# Programmatic **Environmental Impact Statement**

related to decontamination and disposal  
of radioactive wastes resulting from  
March 28, 1979 accident  
Three Mile Island Nuclear Station, Unit 2  
Docket No. 50-320

Final Supplement Dealing with  
Occupational Radiation Dose

October 1984

FIGURE 1.3. Number of Workers Versus Yearly Occupational Dose for TMI-2

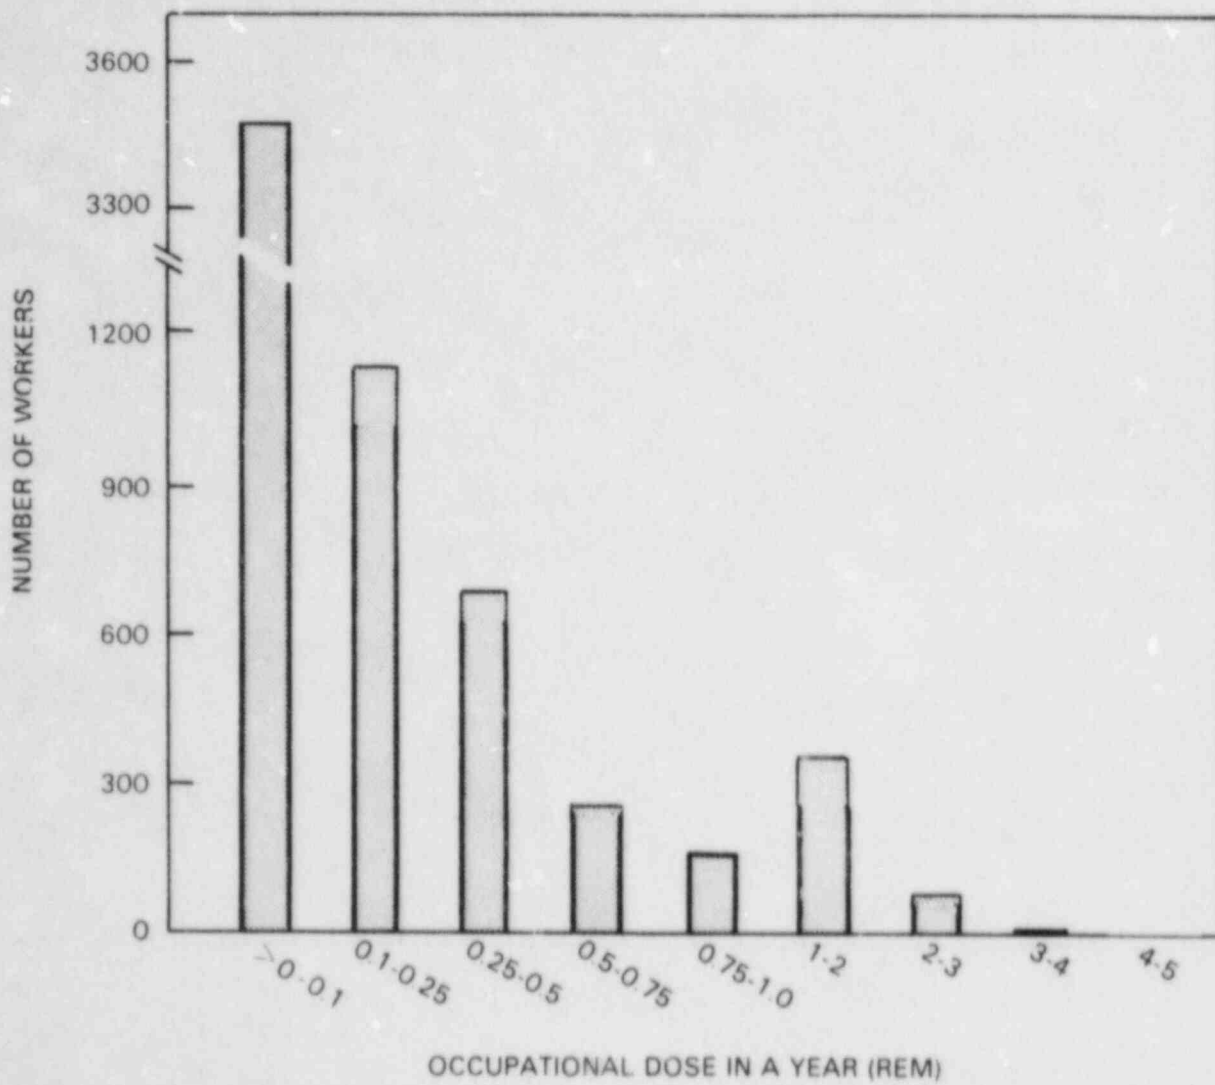
1.8	2	13	Change "the work" to read "each task".						
1.8	3	1	Change "done" to "performed".						
1.9	Figure 1.3		Delete figure and replace with new figure from data in Attachment 4.						
2.1	Section 2.1.1	5	Change "430 mrem/hr" to "0.430 person-rem/person-hour".						
2.3	1	1	Change "140 mrem/hr" to "0.145 person-rem/person-hour".						
2.3	2	1	Change to read "...which is <u>currently</u> reached...".						
2.3	2	4	Change "minimize" to "eliminated the .						
2.4	1	1	Change "240 mrem/hr" to "0.240 person-rem/person-hour".						
2.4	1	1	Change "110 mrem/hr" to "0.110 person-rem/person-hour".						
2.4	2	7	Change "120 mrem/hr" to "0.120 person-rem/person-hour".						
2.4	2	9	Change "80 mrem/hr" to "0.080 person-rem/person-hour".						
2.4	2	9	Add: Dose rates on the reactor vessel/service structure averaged 0.056 person-rem/person-hour. The average airborne activity within the reactor building, based on BZA results, is 15.4 MPC-hours/year. The radioisotopic mix is as follows:

FIGURE 2.6. Cutaway View of TMI-2 Vessel

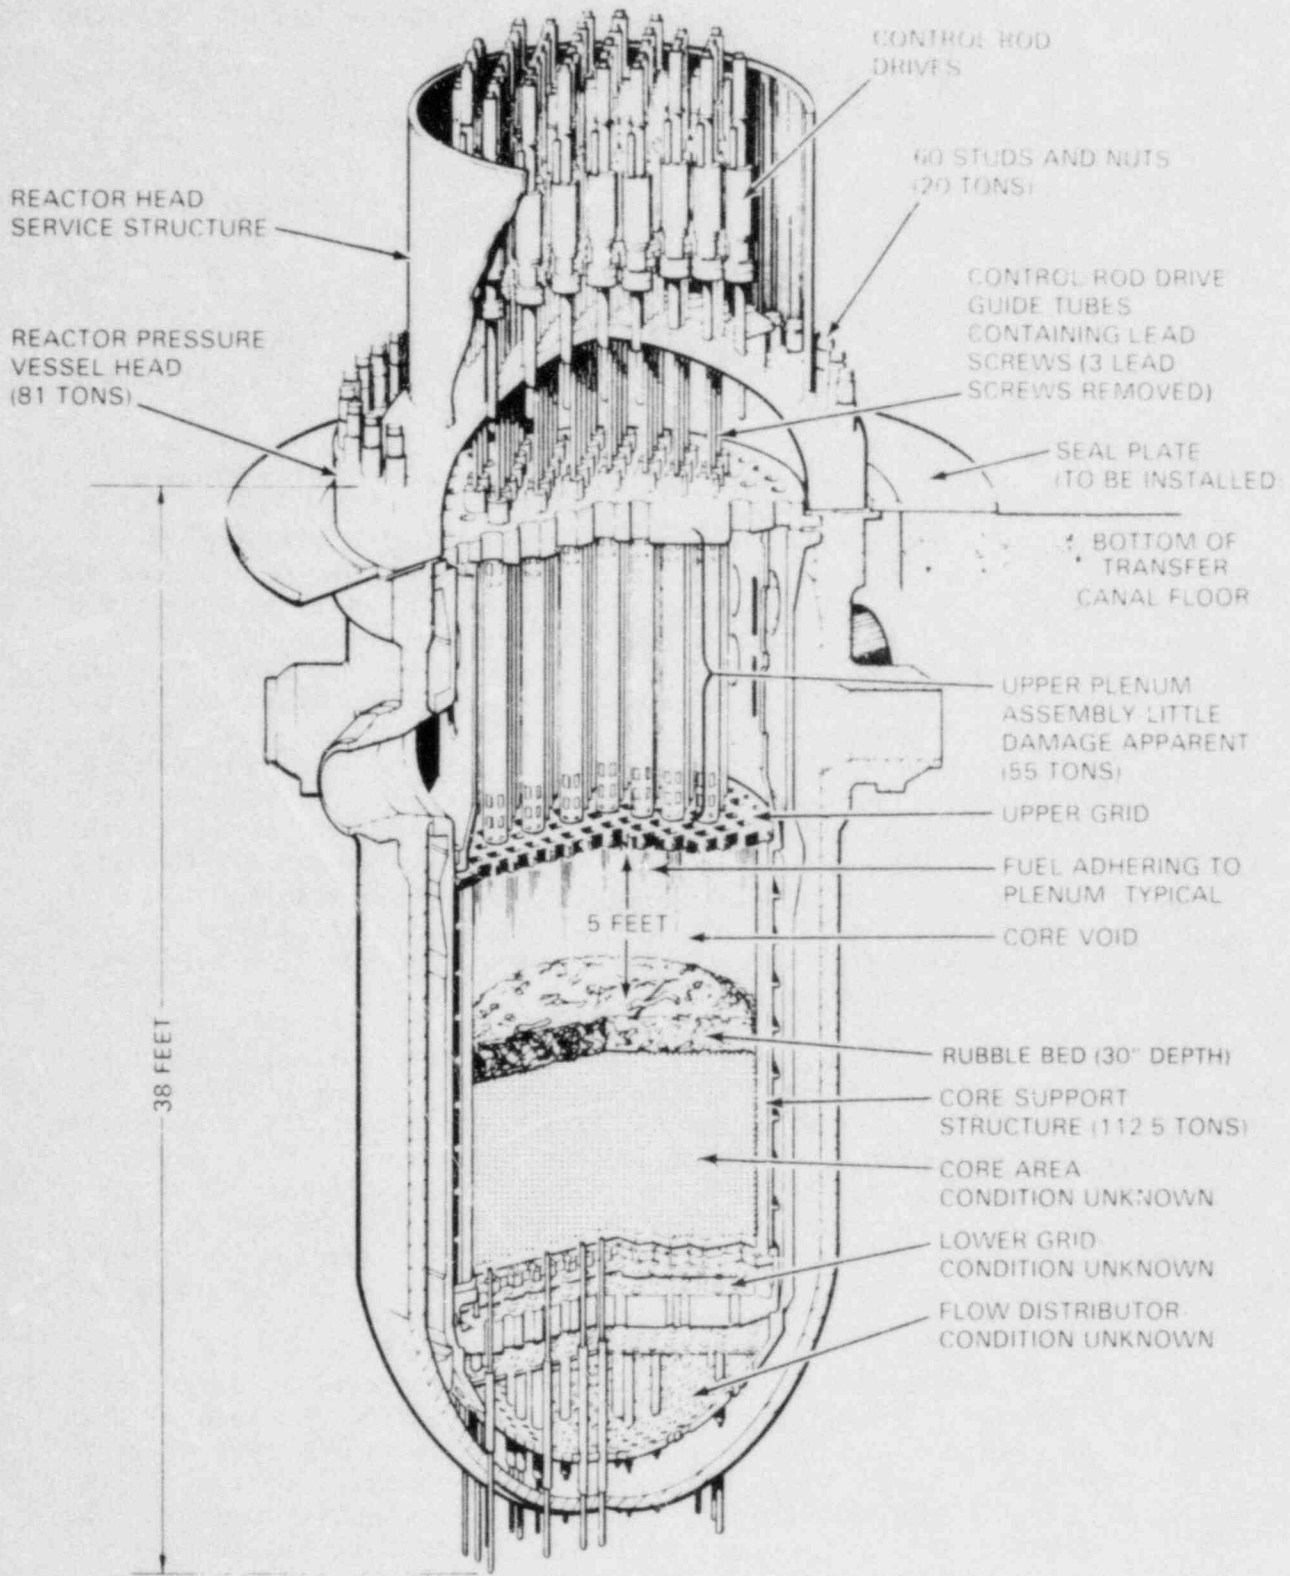
- 1) Below the upper plenum there is a core void of about 5 feet where fuel assemblies have been completely destroyed. Under this there is a rubble bed at least 14 inches in depth. "The conditions below the rubble are not known." (p. 2.8)
- 2) Figure 2.6, a cutaway view of the TMI-2 reactor vessel, shows this uncertainty as to the condition of

FIGURE 2.10. Conceptual Schedule for the Current Plan  
 (a) an interval represents a time period of 6 months to 2 years - see Section 2.6.3.

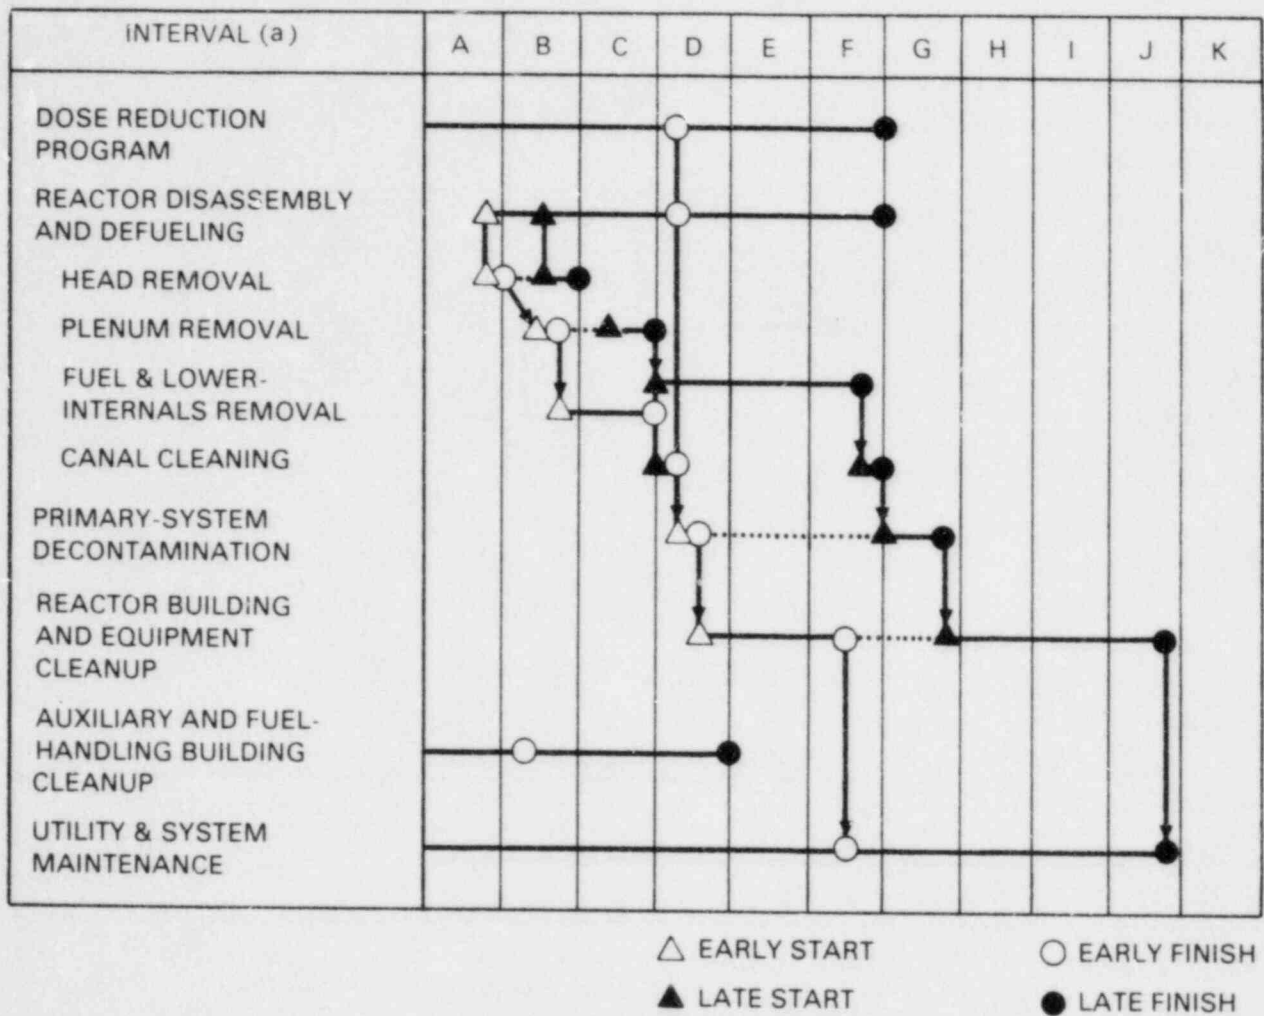
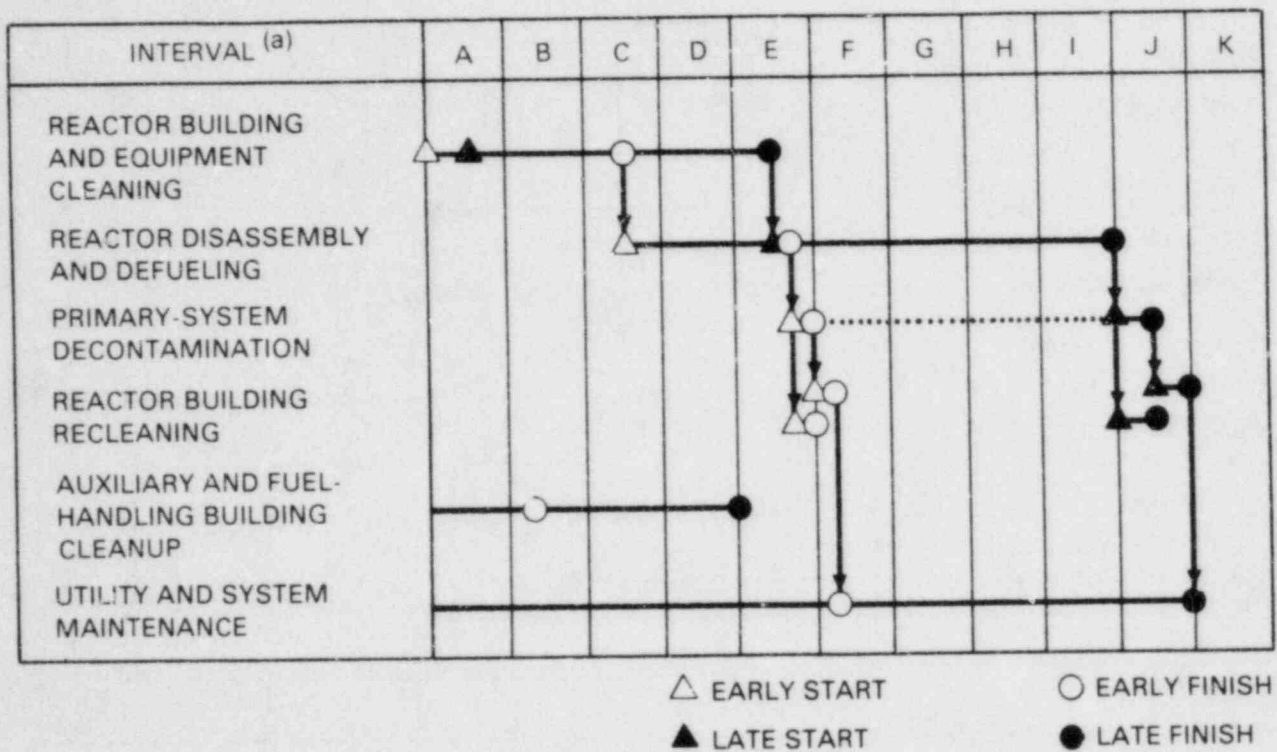
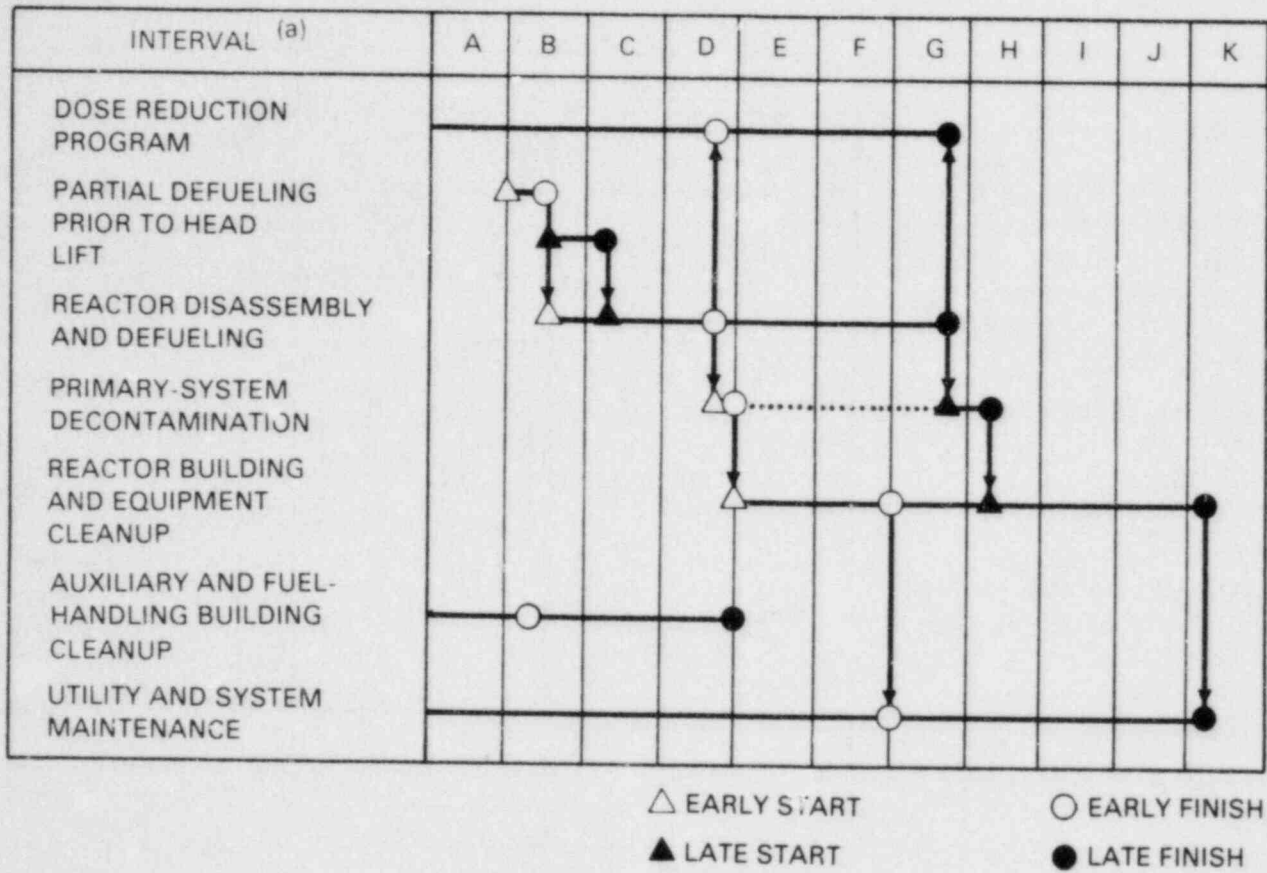
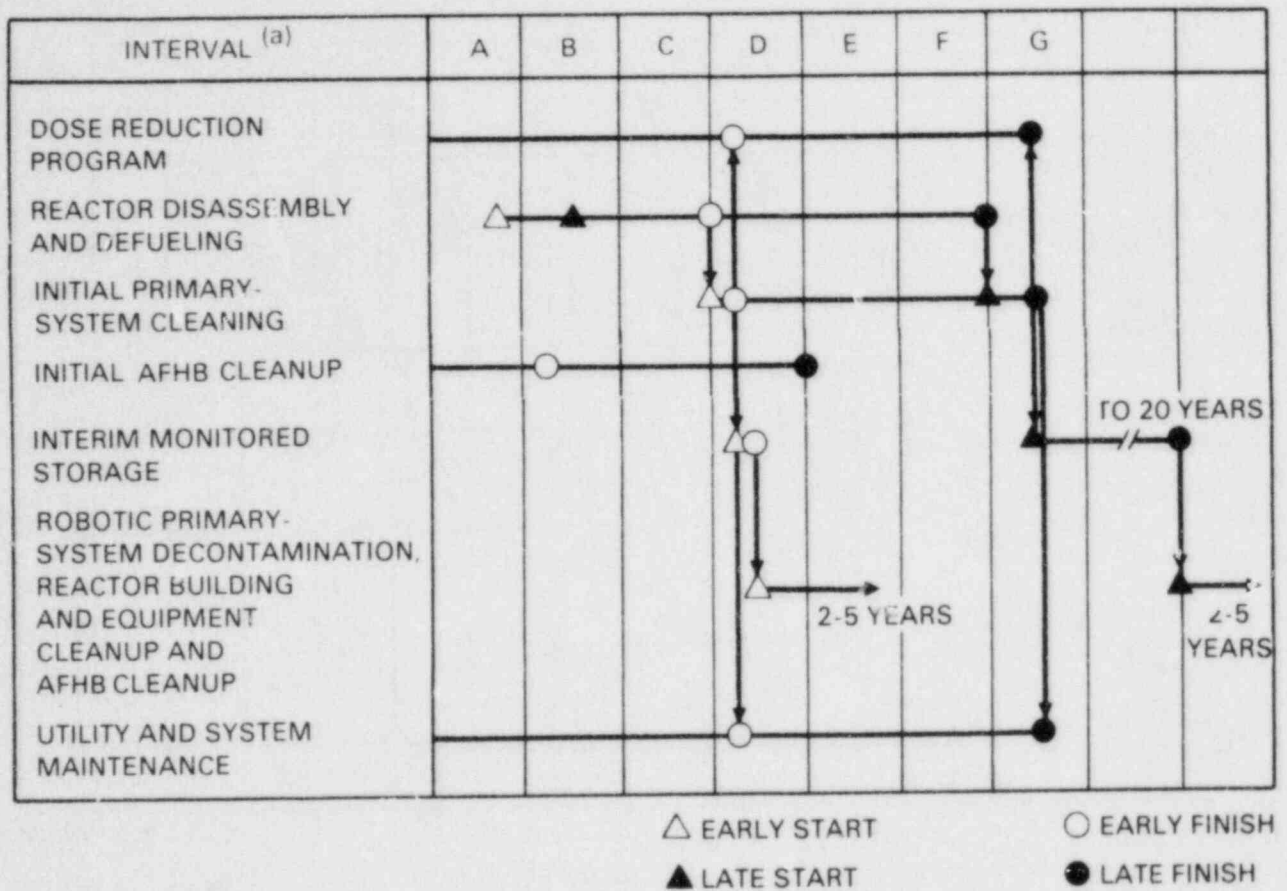
- A statement should be added to Table 2.1, "Licensee's Goals for Dose Rate Reduction", to indicate that these goals are only target values used as a basis for an estimate. They may not be attained and are not a constraint for moving into another period on the cleanup. Additionally, the periods listed in this table are not consistent with the periods shown on Figures 2.10 through 2.13 and as discussed in Section 2.6.3.
